Project Name
120 Archway

Drawing Title
Proposed Elevation DD

Scale	Drawn by
As indicated@ A1	Author
Date	Checked by
17.11.25	Checker
Drawing Number	Revision
24040 - GA - 113	A

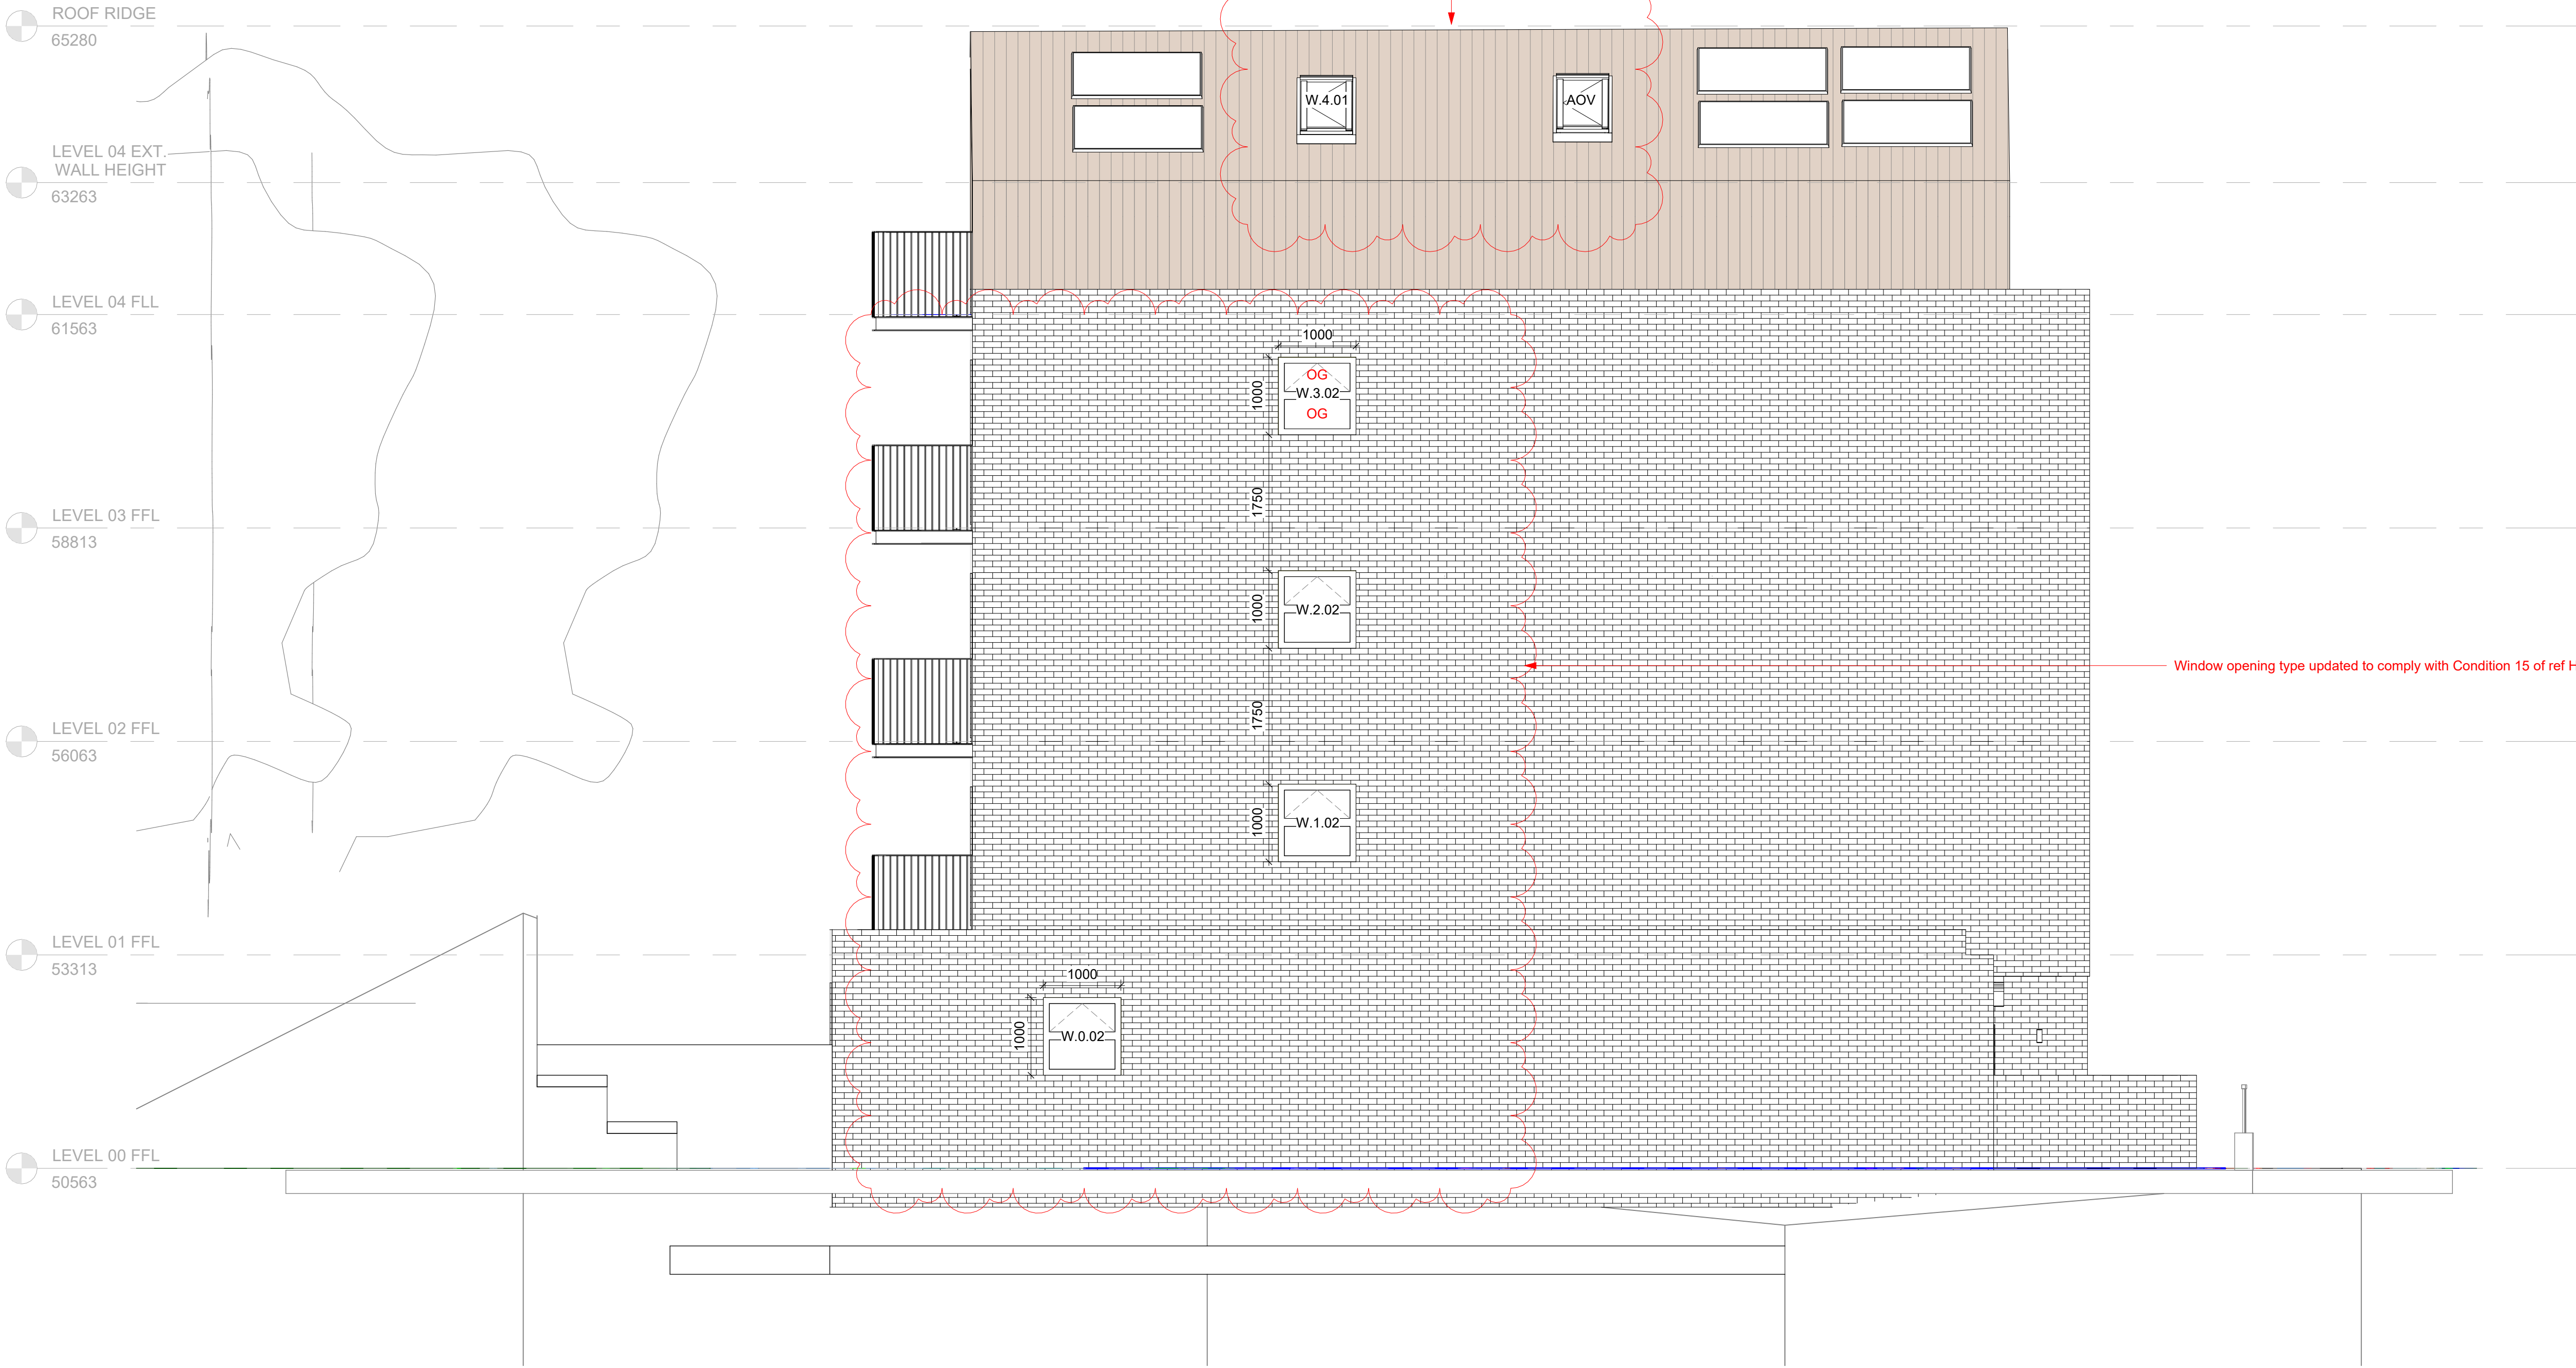
INTRODUCTION OF 2NO. ROOF LIGHT
AND 1NO. AUTOMATIC OPENING VENT
(AOV) FOR FIRE SAFETY
